APPEAL SUMMARY

| Appeal ID: 15716 | Project Address: 9933 NW 107th Ave |
| Appeal Involves: other: Slope on Sanitary Pipe | LUR or Permit Application No.: 17-186129-CO |
| Plan Submitted Option: mail [File 1] | Proposed use: Loading Dock & Trash Enclosure Drains |

1 **ONSITE UTILITY PLAN**
C2.1 SCALE: 1" = 10'-0"

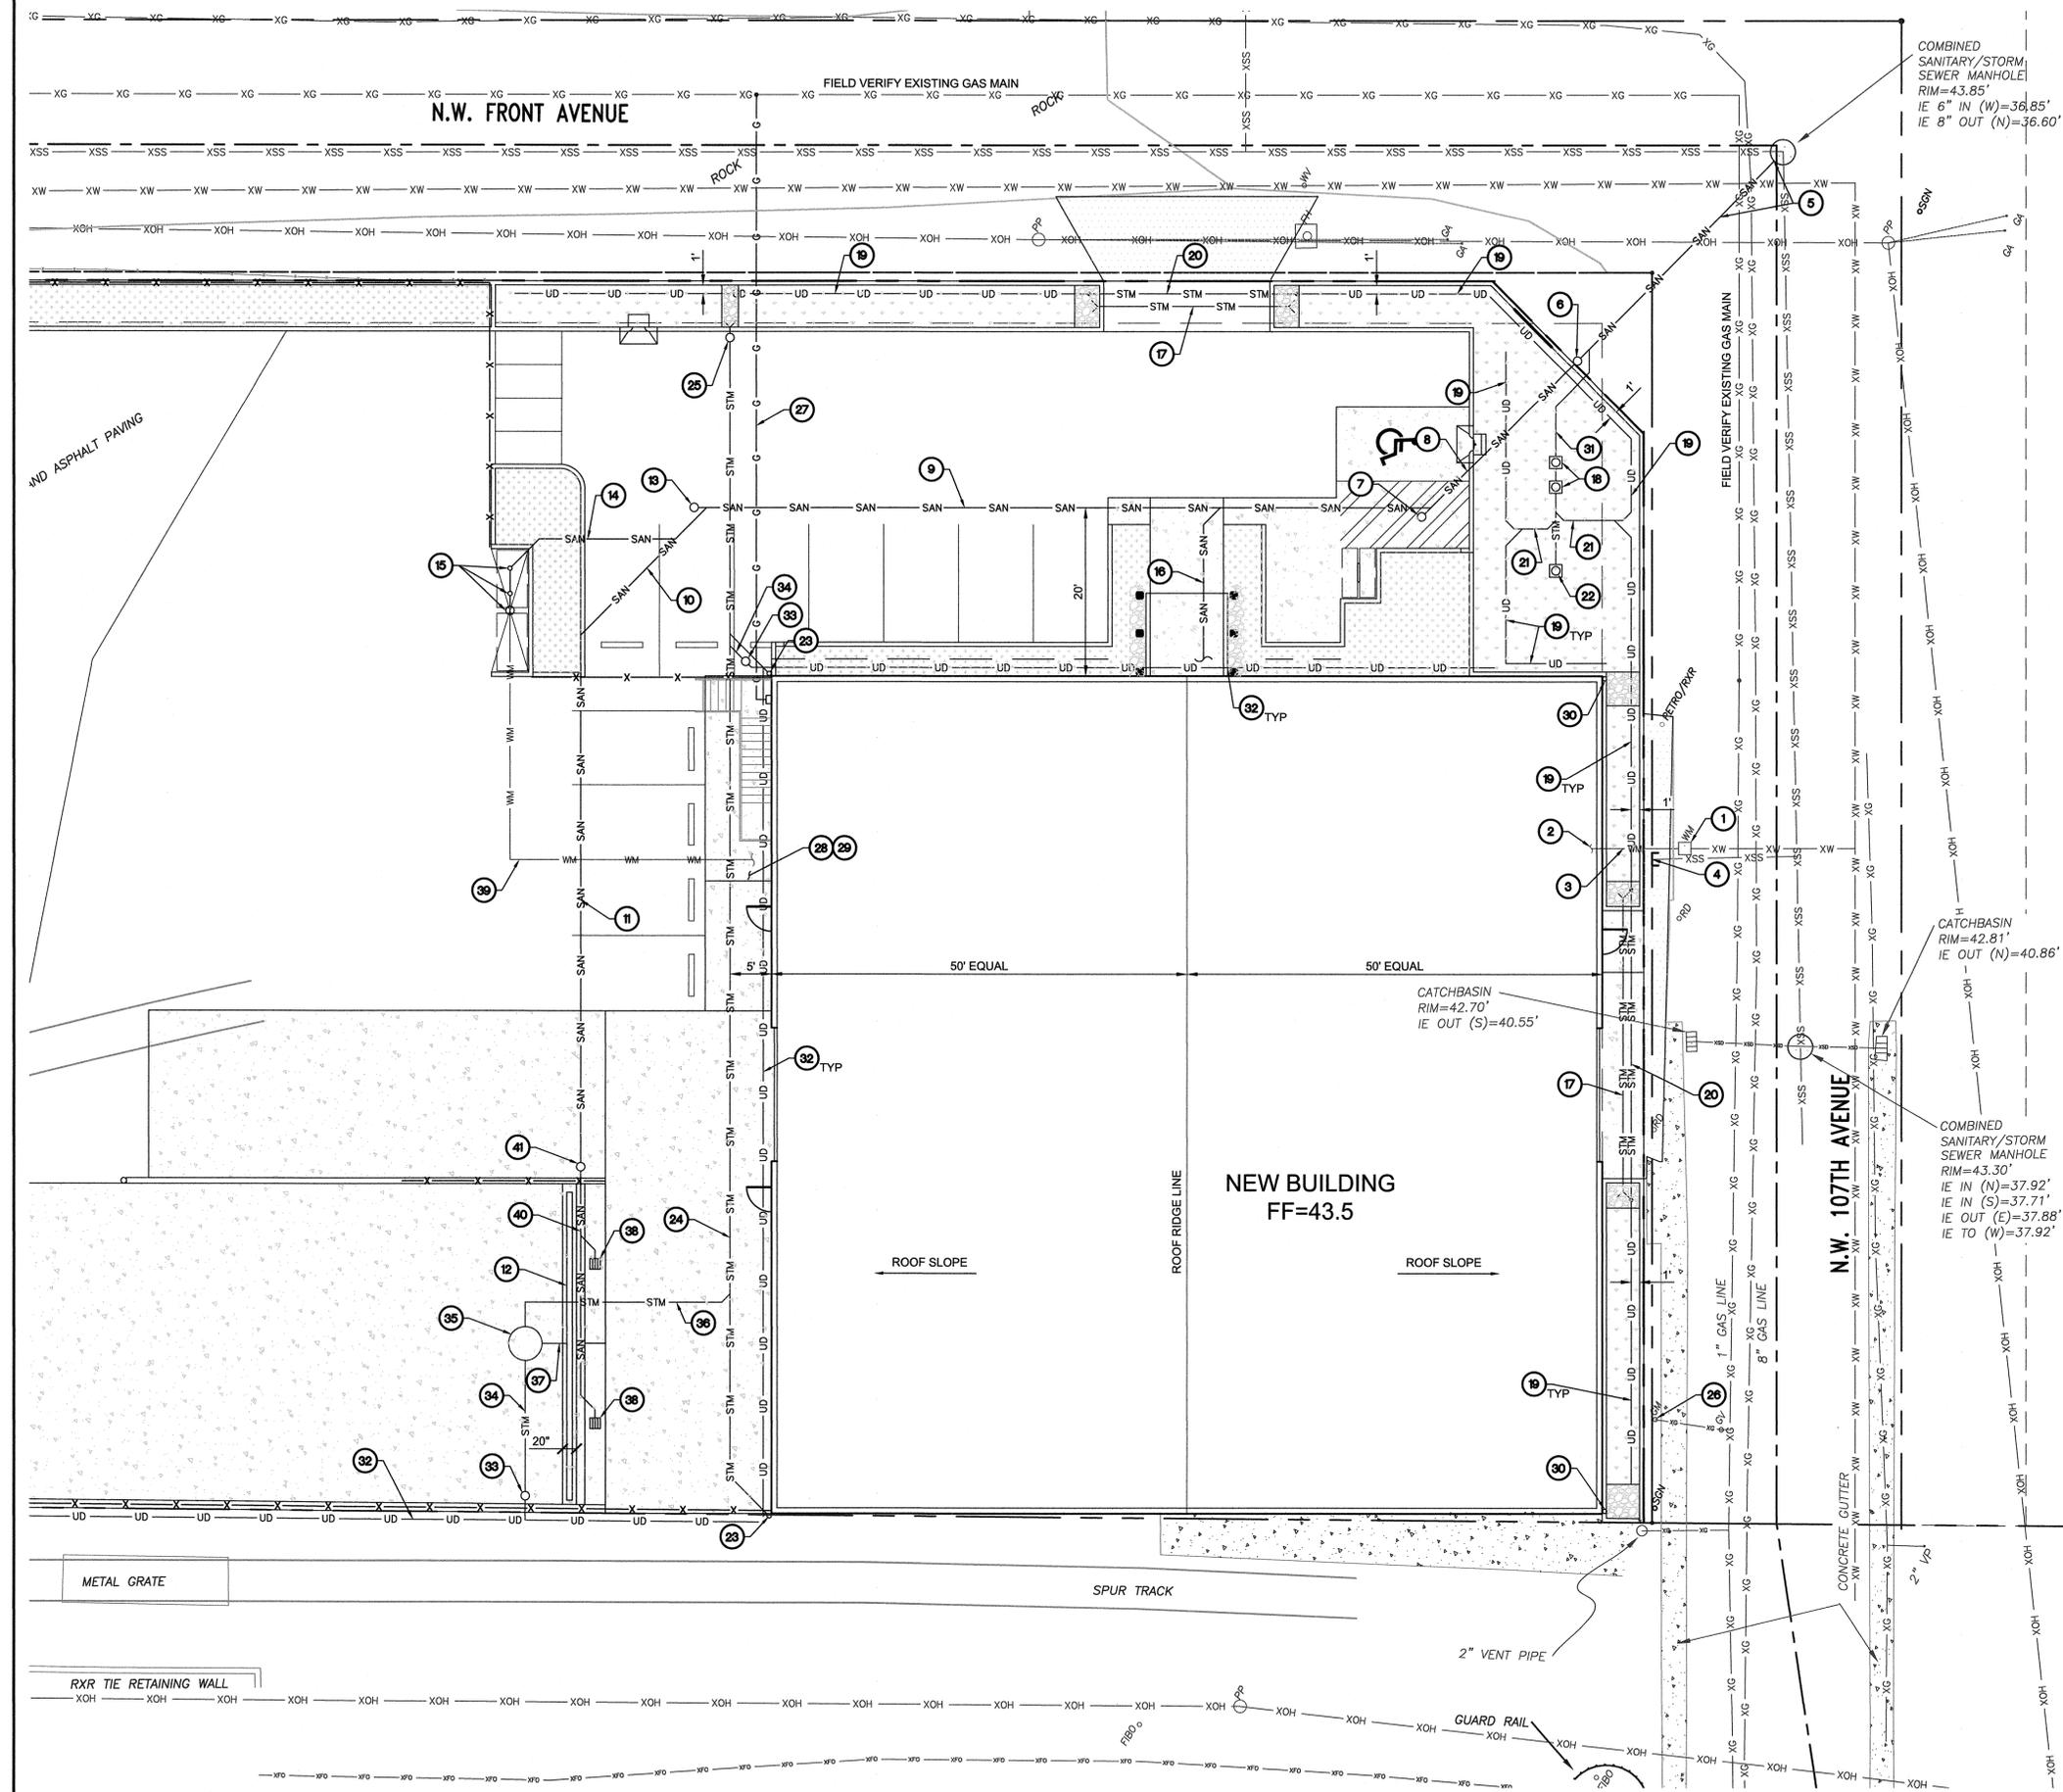
Code Section OSPC 2014 Table 7-8, 708.1

Requires Sanitary sewer piping to be at 1.0% minimum slope

Proposed Design The onsite sanitary piping can only achieve up to 0.5% slope. The existing public manhole is shallow. The sanitary pipe will need to convey flow from a two new loading dock area drains and from one new trash enclosure drain. The trash enclosure lateral to the private site main will slope at 2%. The building main will slope at 2% inside the building and connect to the site main at 2% slope. The site main will be an 8-inch sloping at 0.5% and the line to the loading dock drains is proposed to be 4-inch at 0.5% slope.

Reason for alternative The existing manhole in the public right of way is shallow and there is not enough grade to achieve greater slopes and minimum cover back to the loading dock area. The loading dock and trash enclosure drains should not be receiving constant water flow. The building main will connect to the 8-inch private site main at a 2% slope with a "wye" fitting. This is sufficient to achieve a safe conveyance for the proposed development. Additionally, BES was not wanting to connect further downstream in NW Front Avenue due to that line being under surcharge during rain events.

Reduced slope of 0.5% for sanitary sewer pipe serving loading dock and trash enclosure drains: Granted as proposed.

The Administrative Appeal Board finds that the information submitted by the appellant demonstrates that the approved modifications or alternate methods are consistent with the intent of the code; do not lessen health, safety, accessibility, life, fire safety or structural requirements; and that special conditions unique to this project make strict application of those code sections impractical.
